**Appendix A –
Responses-to-Comments Table
(Departmental Comments)**

Section 16 Planning Application for Proposed Amendments to an Approved Comprehensive Residential Development Scheme and Minor Relaxation of Gross Floor Area and Building Height Restrictions at Various Lots in D.D. 385 and Adjoining Government Land, Tai Lam Chung, Tuen Mun (Application No. A/TM-SKW/134)

Responses to Departmental Comments

Extract of EA for Application No. Y/TW/18 (for reference)

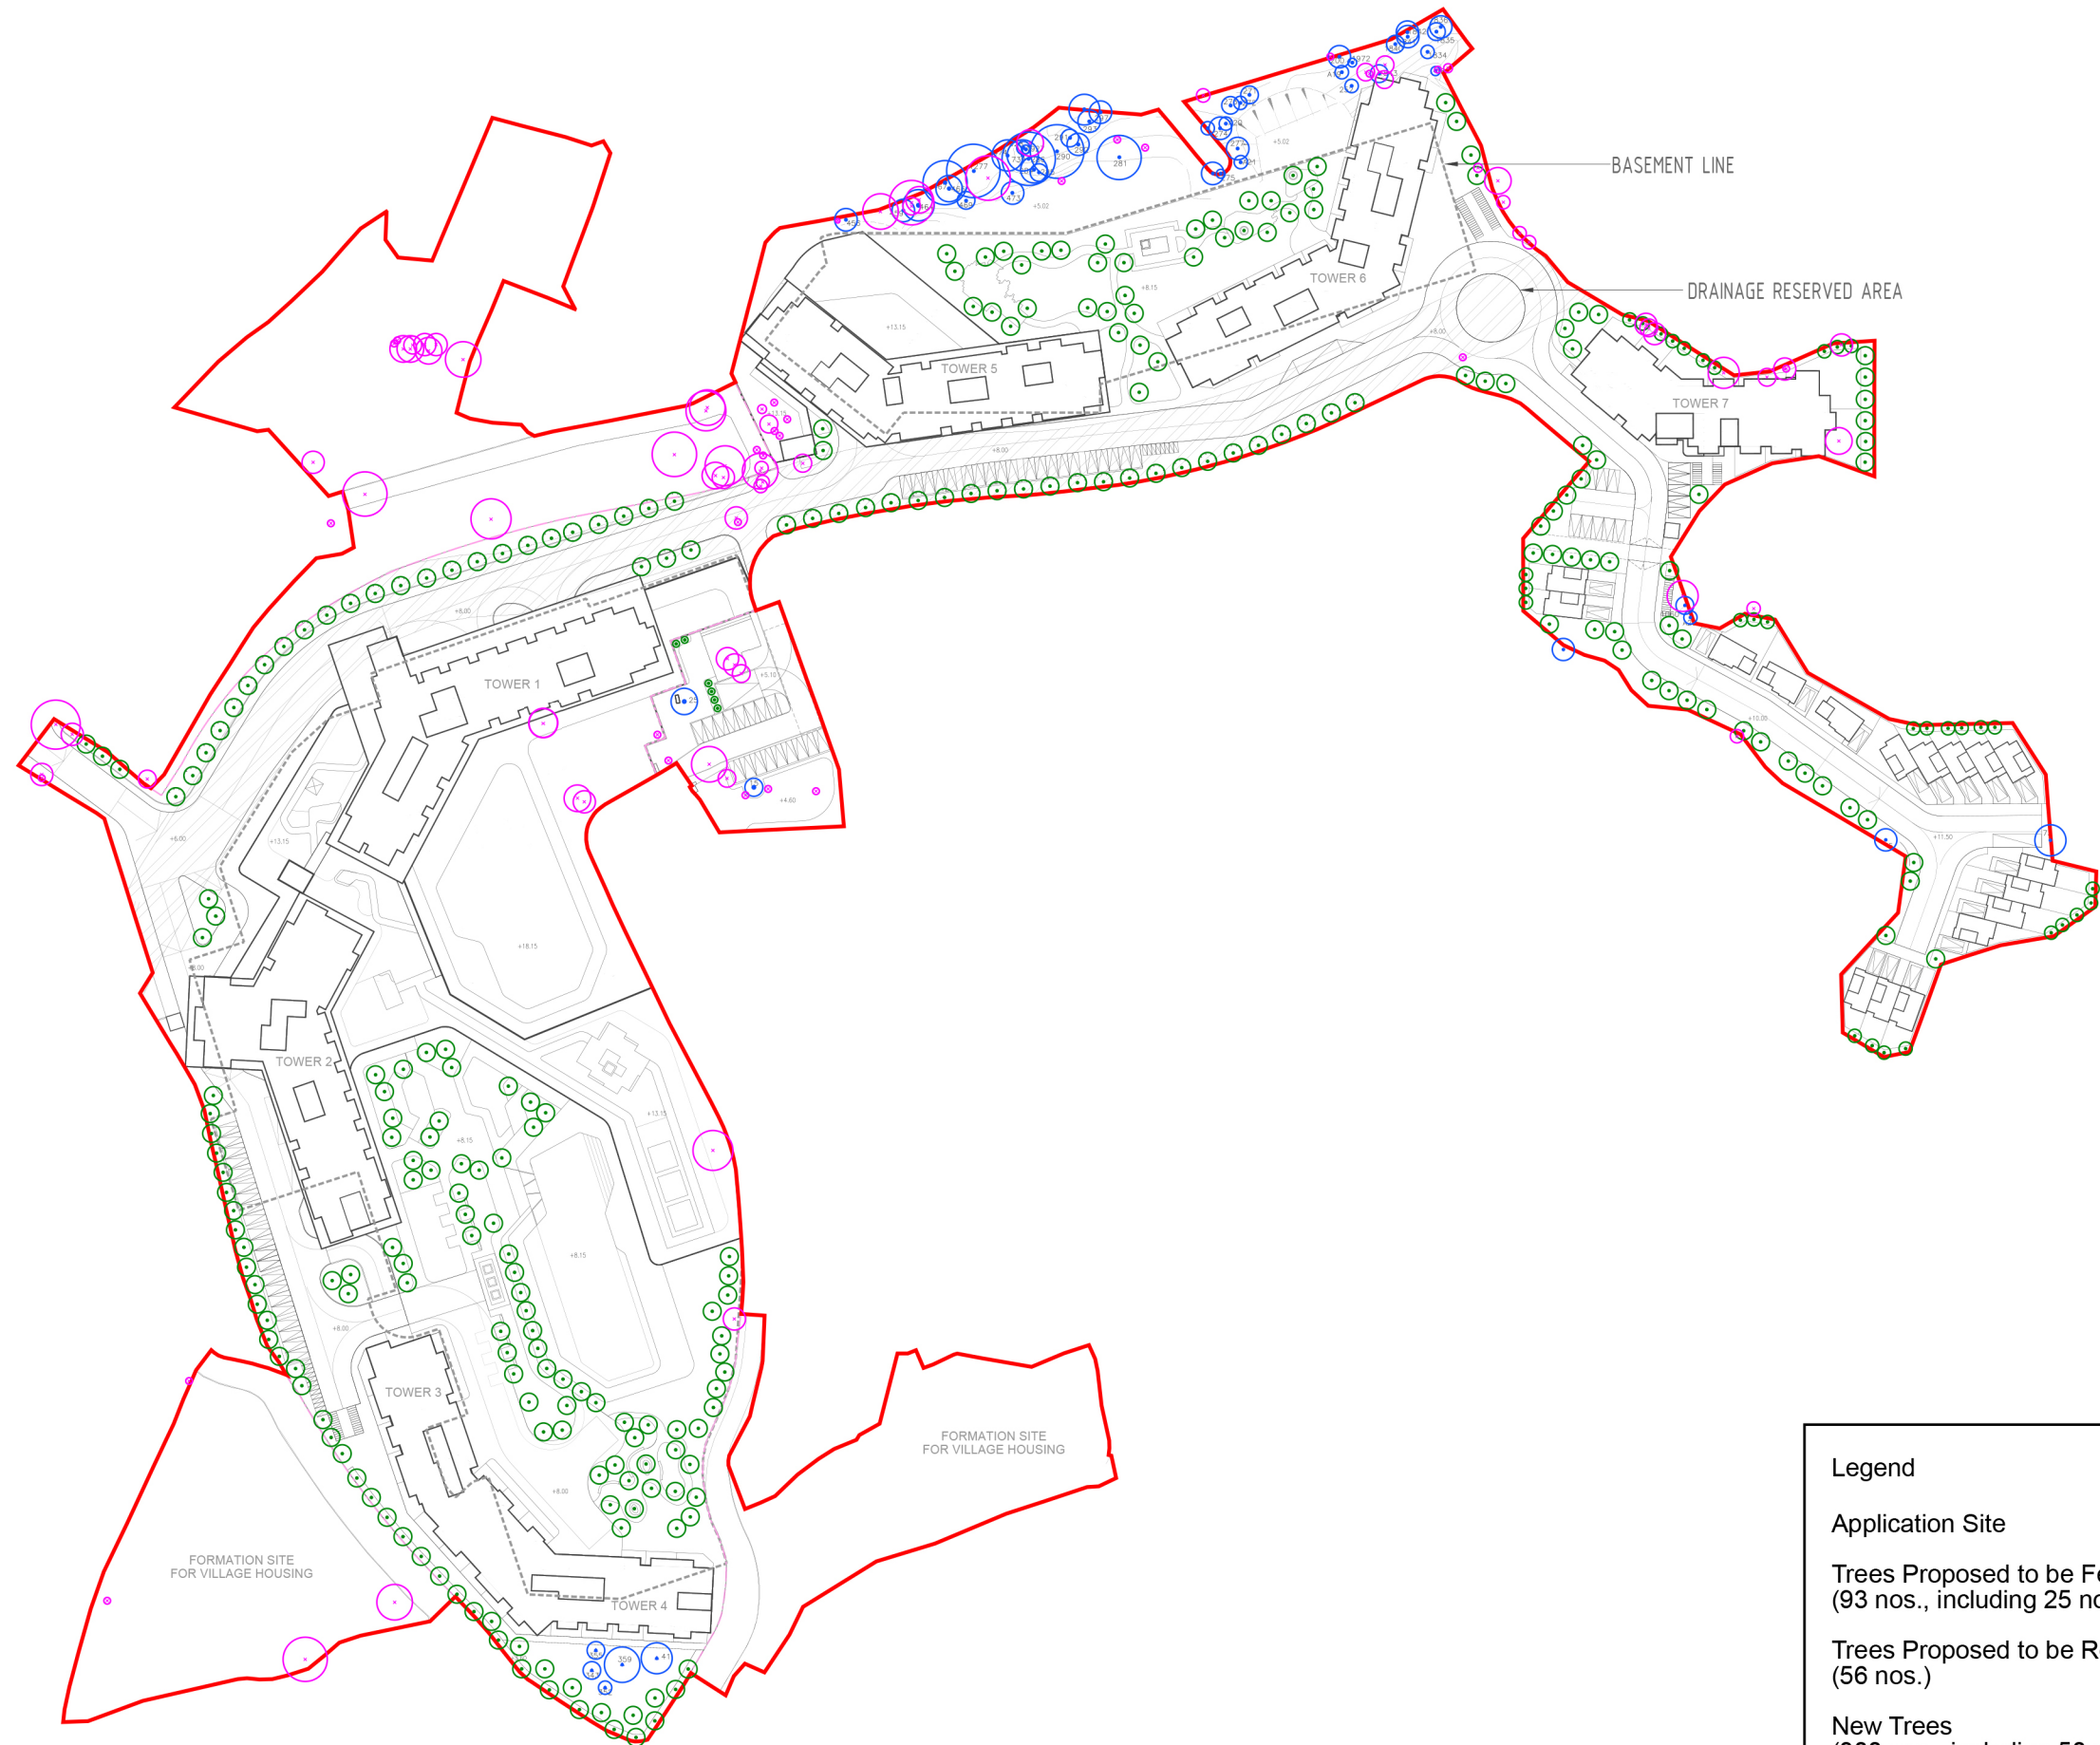
Departmental Comments	Responses to Comments
2.3	<ul style="list-style-type: none"> Please revise “5m buffer distance” and “10 m buffer distance” in the second-to-last line to “buffer distance of >5 m” and “buffer distance of >10 m”. <p>Section 4.6.3 – It is noted that the detailed information of the proposed STPs is not available yet, therefore the proponent has committed to submit an odour impact assessment during detailed design stage once the design of the two STPs is available to identify the removal efficiency required for the two STPs. For completeness, please be advised to evaluate the odour impact of the STPs in the EA report.</p>	<ul style="list-style-type: none"> Noted. Section 4.4.4 of the revised EA under Attachment 1 has been revised accordingly. <p>Section 4.6.7 of the revised EA under Attachment 1 has been revised as follows: “With adequate odour removal system and regular maintenance, the odour impact due to the operation of the STPs minimised. However, to be conservative, odour impact assessment will be conducted during the detailed design stage.”</p> <p>The above commitment regarding the preparation of a quantitative odour impact assessment at the detailed design stage is consistent with other agreed/approved planning applications which provided no detailed information on the STP, such as Application No. Y/TW/18 at Yau Kam Tau (partially agreed on 19.9.2025) and Application No. A/DPA/SK-CWBN/12 at Clear Water Bay (approved on 19.11.2004):</p> <ul style="list-style-type: none"> For Application No. Y/TW/18, the relevant wording in the EA report is attached under Annex C for easy reference; For Application No. A/DPA/SK-CWBN/12, the wording of approval condition (c) regarding quantitative odour impact assessment is as follows: “the submission and implementation of environmental mitigation proposals (including traffic noise and odour impact assessments) within the site to the satisfaction of the Director of Environmental Protection or of the Town Planning Board”. <p>To further supplement on the design of the STPs:</p> <ul style="list-style-type: none"> As discussed in Section 4.6 of the revised EA under Attachment 1, the STPs with design capacity of 881m³/day and 1,408m³/day are fully enclosed and located underneath Towers 1 and 5. Their locations have been indicated in Appendix 4.2 of the revised EA. Their design will refer to EPD’s “Guidelines for the Design of Small Sewage Treatment

Departmental Comments	Responses to Comments
		<p>Plants”, with exhaust facing away from air sensitive uses to ensure not causing odour impact to the occupants/residents of the air sensitive uses including the surrounding developments and the Application Site. The potential locations of the exhausts of the proposed STPs and its distance to air sensitive receivers are shown in Figures 4.3a and 4.3b of the revised EA. To minimize the potential odour nuisance, the mechanical ventilation system of the STPs will be connected to an odour removal system which shall achieve removal efficiency of 99.5%. With the adoption of odour removal system, it is anticipated that the surroundings air sensitive receivers will not be subject to unacceptable odour impact from the operation of the proposed STPs. Apart from adoption of odour removal system, regular maintenance, for example regular sludge removal to prevent accumulation of odourous gas, would be carried out to ensure the odour removal efficient is maintained at/above the design requirement. Sludge tankers will be used to transport the sludge, which is expected to be transported to T Park by registered desludging companies. The tanker will park at the basement carpark near the STPs and sludge will be pumped by coupling. The odourous gas will be confined within the STP which will be kept under negative pressure. The gas will be drawn to a de-odouring system for treatment before releasing into the atmosphere. As the transfer process will be carried out in enclosed environment and in low frequency (one time per day), no odour impact is expected on ASRs during handling of sludge;</p> <ul style="list-style-type: none"> • In terms of sewage effluent, as discussed in Section 5.7 of the revised EA under Attachment 1, membrane bioreactor (MBR), which achieves tertiary wastewater treatment level, will be adopted for the Proposed Development to meet North Western Water Control Zone effluent discharge standards. The treated effluent will be discharged to Tai Lam Chung Nullah through the proposed box culvert. It is expected that the operation of the STPs would not cause water quality
